Mareeba Shire Council
65 Rankin Street
PO Box 154
Mareeba QLD 4880

**Response to Pre-Request for Information
2-4 Quill Street, Mareeba (OPW/21/0006)**

QUILL STREET LAND DEVELOPMENT

PROJECT REF		CONMAT PTY LTD	
		QUILL STREET LAND DEVELOPMENT	
DRAWING REF		DRIVEWAY PLAN	
DRAWING NO		160-001-C105	
SIZE	A3	REVISION	B

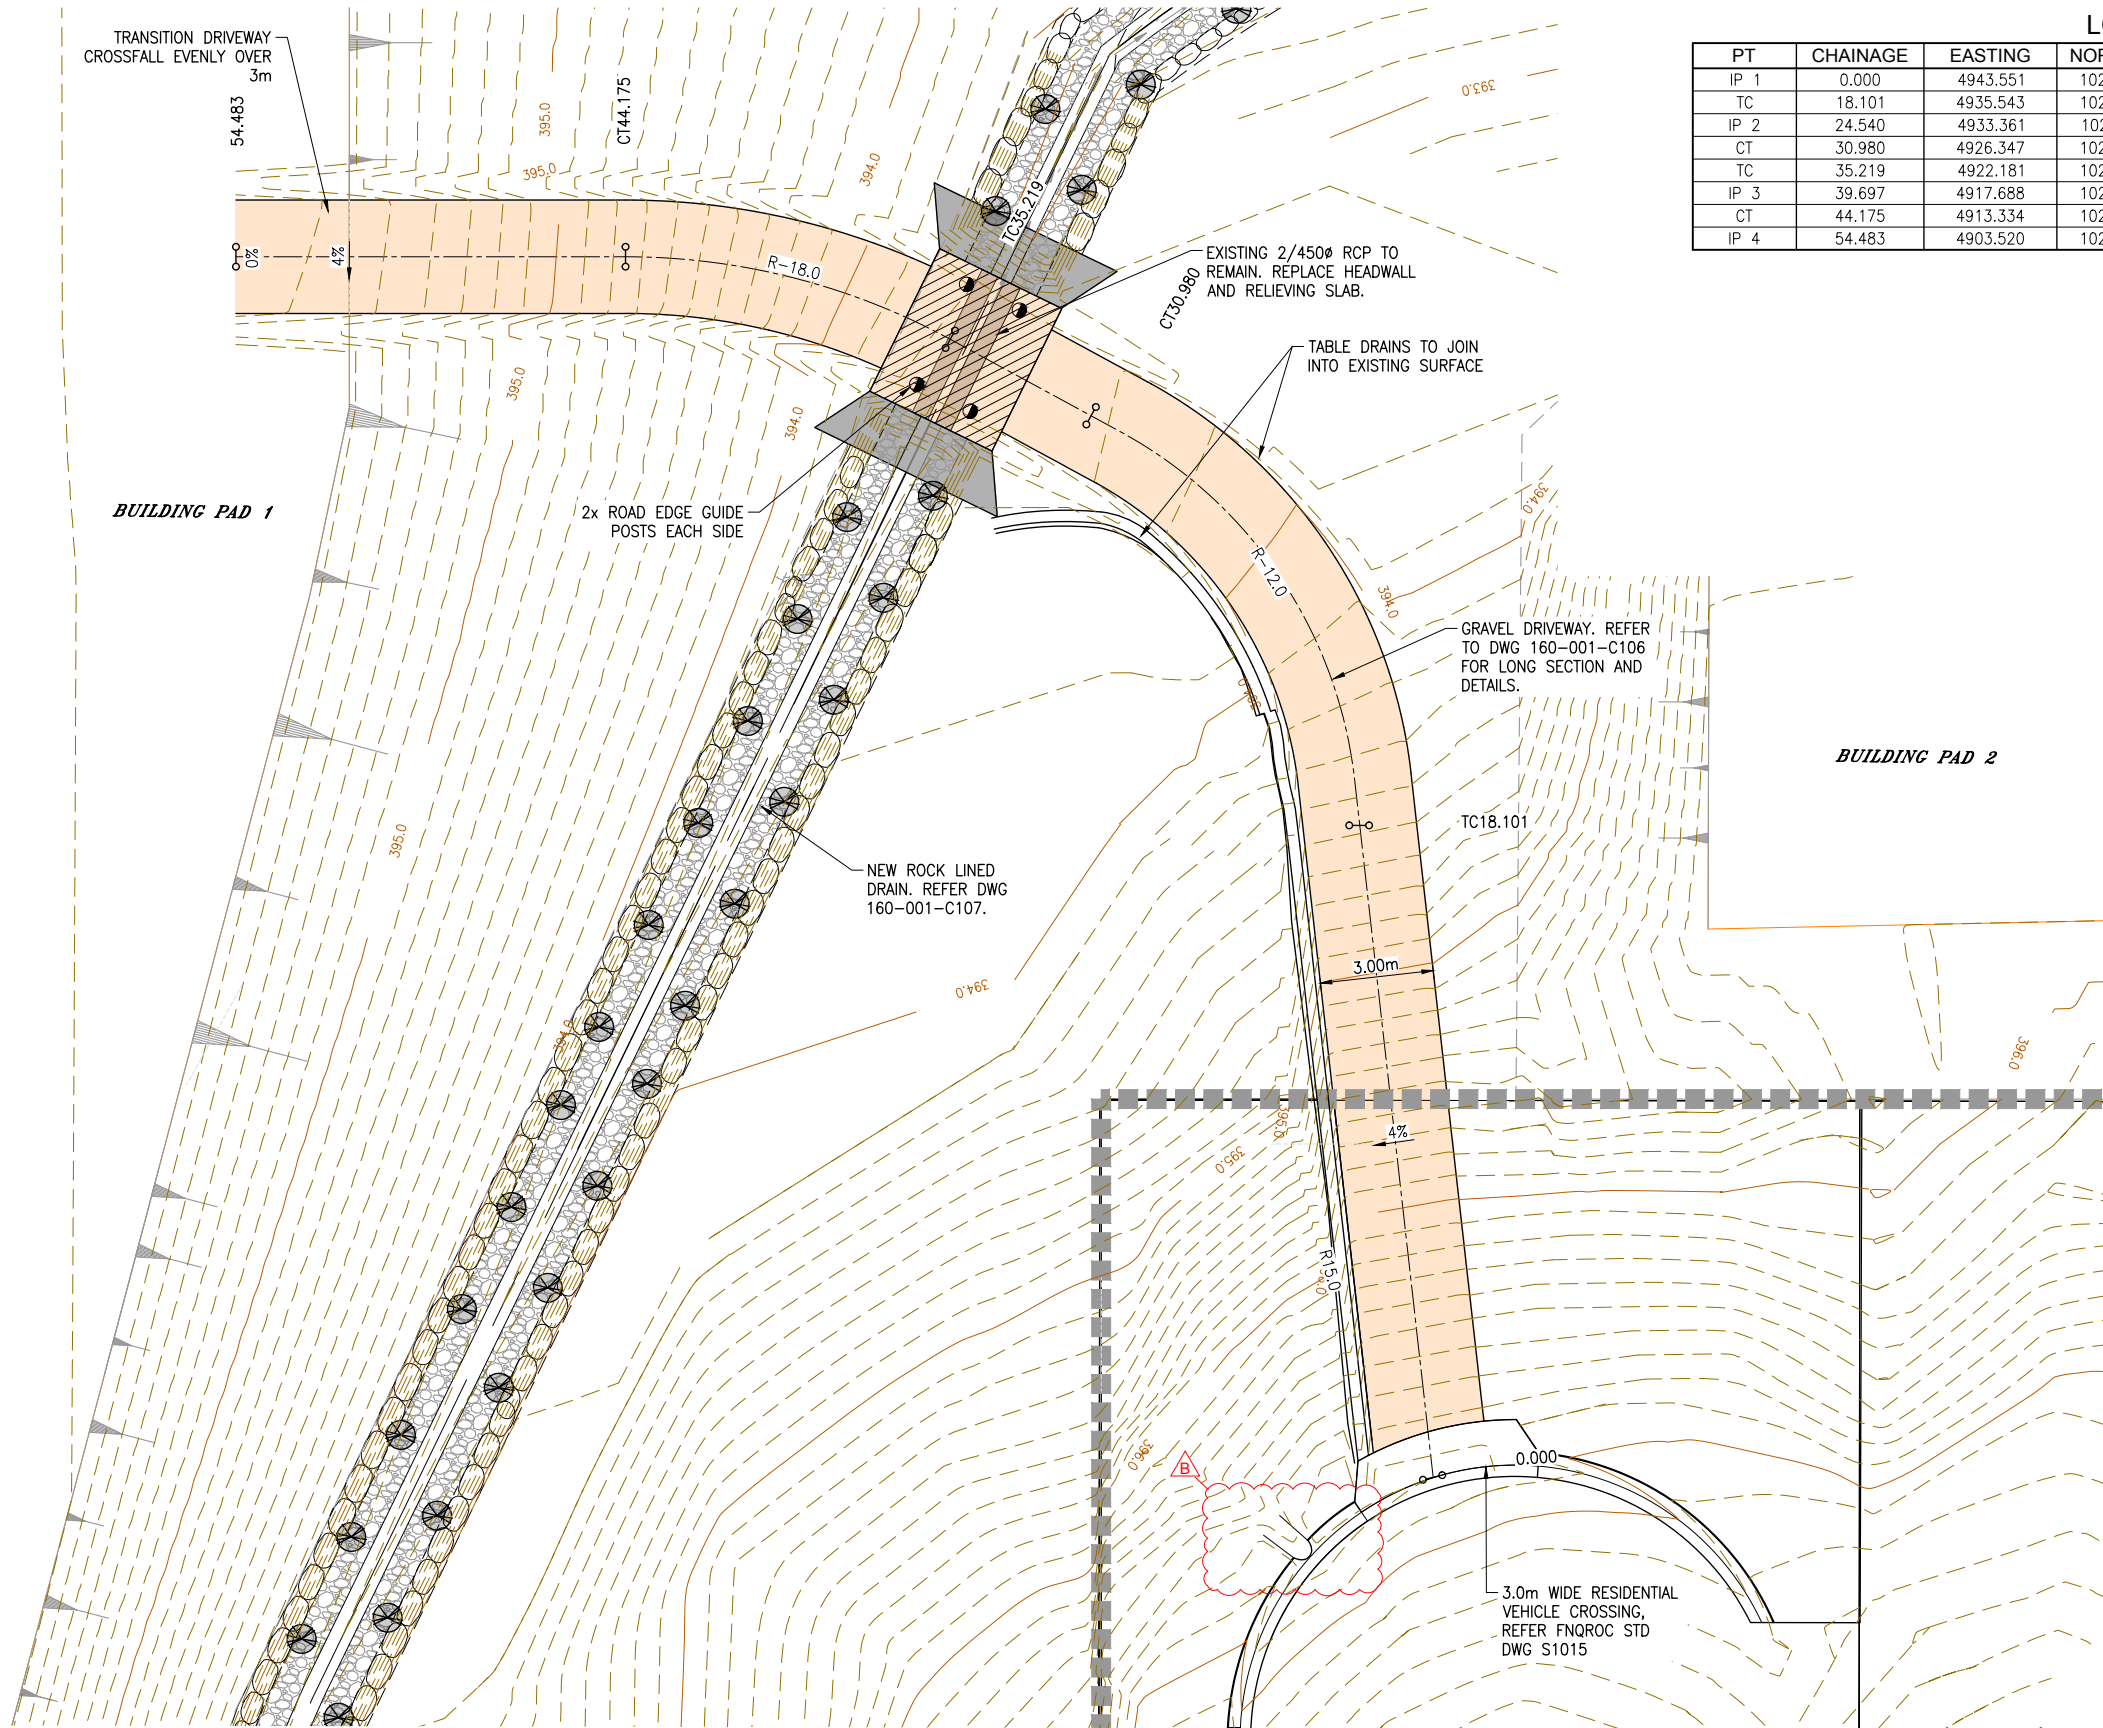
1. For the works proposed within the Quill Street road reserve, provide the following information:
 - a. Clarify the linework included on the drawings for works at the end of Quill Street. The linework appears to include a kerb inlet pit, additional driveway crossover to the west and a section of concrete behind the kerb. [Plan work will be supplied at the RFI, further detailing the crossover kerb and driveway. The indicated kerb inlet pit at the Quill Street Cul-de-sac head will be removed from the plan and replaced with a kerb outlet to an overland flow, which represents the existing conditions. Please see amended drawing 160-001-C105-Rev B.](#)

- b. Provide amended drawings showing the existing and finished surface contours at 100 mm intervals to enable an assessment of the finished surface proposed at the Quill Street cul-de-sac and the driveway segment within the road reserve. [Please see amended drawing 160-001-C105-Rev B which shows the existing and design contours at 100mm intervals.](#)

- c. For the proposed driveway to Building Pad 1, provide confirmation on the driveway grade within the Quill Street Road reserve (noting 5% desirable maximum verge grade). The designer is also requested to check the change in grade from the proposed driveway crossover and confirm if any transition segment is required for this change in grade. [Access to the second building pad will be at the discretion of the property owner and will dependant on it's intended use. A primary driveway has been provided to the main building pad.](#)

2. The location of existing power pole stay wire at the northern end of Quill Street must be shown on the Engineering Drawings to demonstrate that the proposed driveway and on-street works do not impact on this existing infrastructure.

An amended plan will be issued with the RFI response which will show an adjusted driveway alignment to create a buffer with the stay wire.

DRAWING NO	SIZE	REVISION
160-001-C106	A3	B

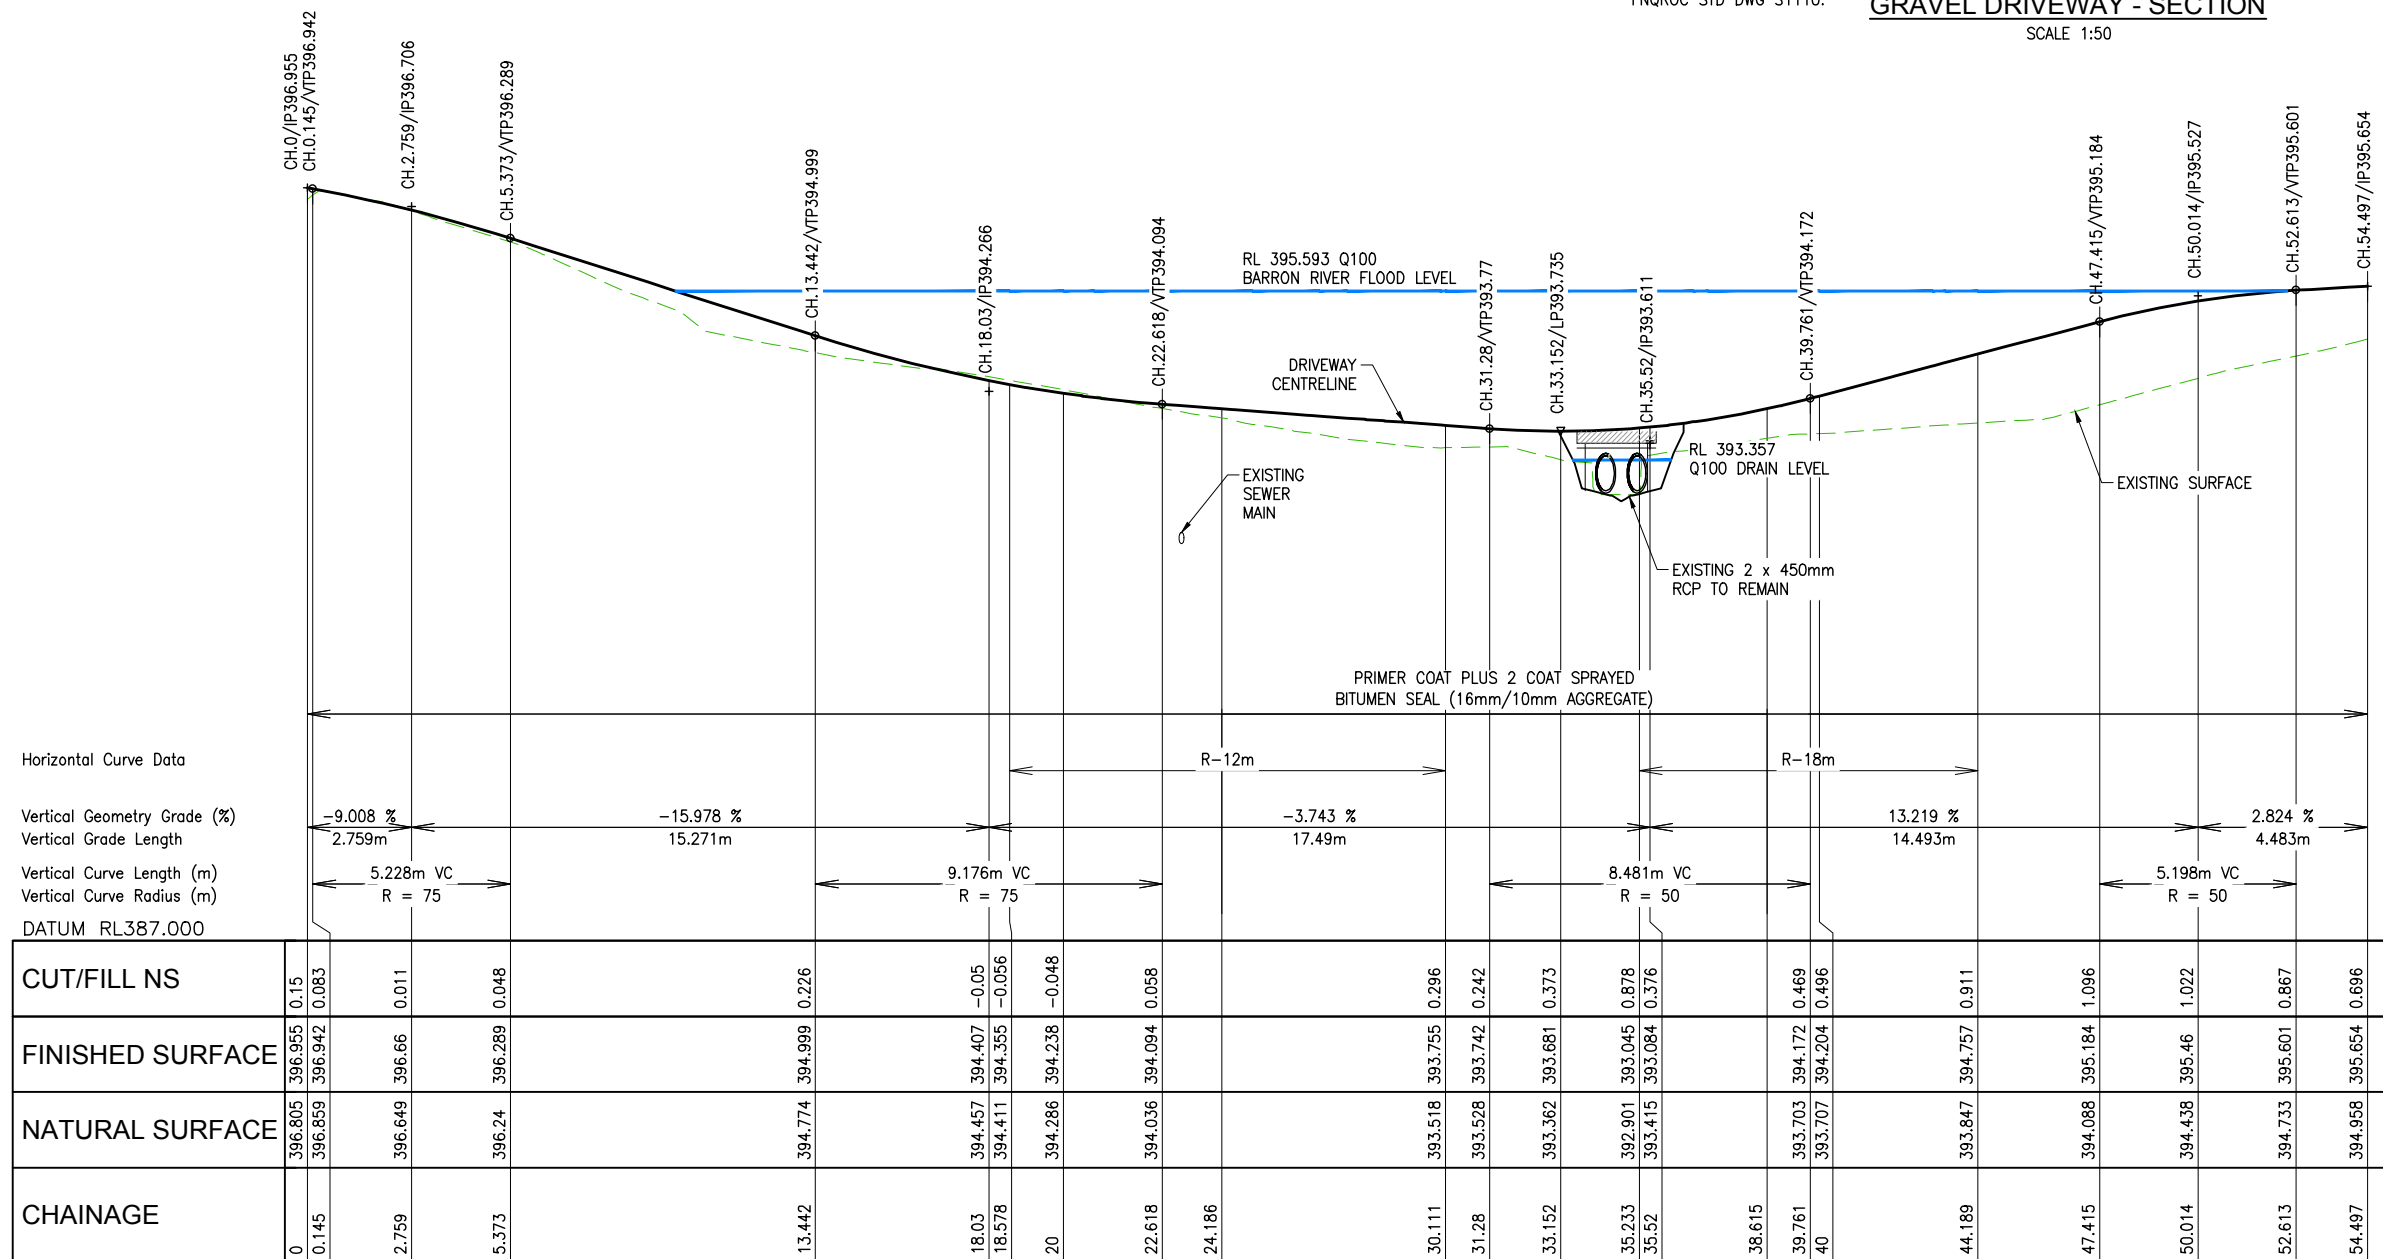
8. Confirm the data source for the 1% AEP flood level shown on the cross section on Drawing C106. Amend the drawings to include the level value (RL) determined for the 1%AEP (Q100) water surface on the drawing C106.

If the flood level shown does not represent Barron River flooding, provide advice on the immunity of the driveway from a Barron River flood event. (That is; what frequency/occurrence event overtops the driveway).

Advice Note; The inundation extent shown on SK07 in Appendix C of the design report appears to differ from water level shown on Drawing C106. The applicant is requested to clarify the different flood levels/extents.

10. The designer is to amend the drawings to provide concrete lining for all catch drains. The drawings must provide details of concrete lining, including but not limited to; location, lining thickness, lining extent/height within drain cross section, reinforcement details, jointing. The requirement for drain lining also applies to the proposed drain beside the driveway shown on drawing C106 given the driveway longitudinal grade is approximately 16%.

12. The applicant is requested to provide updated drawings, including a sealed driveway for the full extent and scour protection measures for the portion of the driveway expected to overtop during rainfall events.

The Q100 level for the backflow of the Barron River of RL395.593 was supplied by council. The RL achieved for the stream flow Q100 RL 393.357 is based on our calculations of contributing catchments and a flow height of 597mm above the invert level.

The driveway will be sealed with a primer coat plus 2 coat sprayed bitumen seal (16mm 10mm) for the full length. The overland flow will be contained within the 2x450 RCP. If a blockage occurs, the road at the culvert will overflow a design of 300mm.
